Request for class II permissive change

FCC ID:A3LLS24C370

Date:2013/06/05

The photos for the Adapter

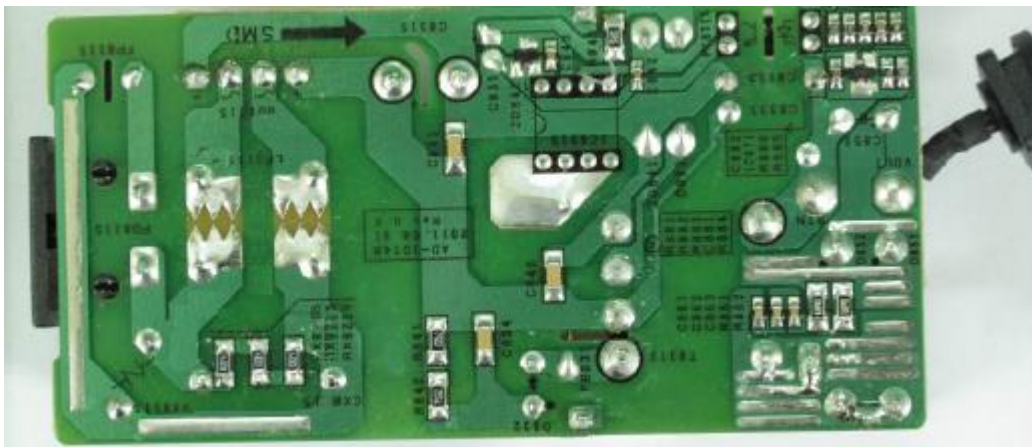
1:Change to use new Adapter

Item	Change information		Remark
	Before	After	
Adapter	AD-3014B	A2514_DPN	Use new adapter
Spec	2.14A	1.78A	Use new Spec

Before change
AD-3014B external front view

Before change
AD-3014B external rear view

Before change
AD-3014B internal front view

Before change
AD-3014B internal rear view
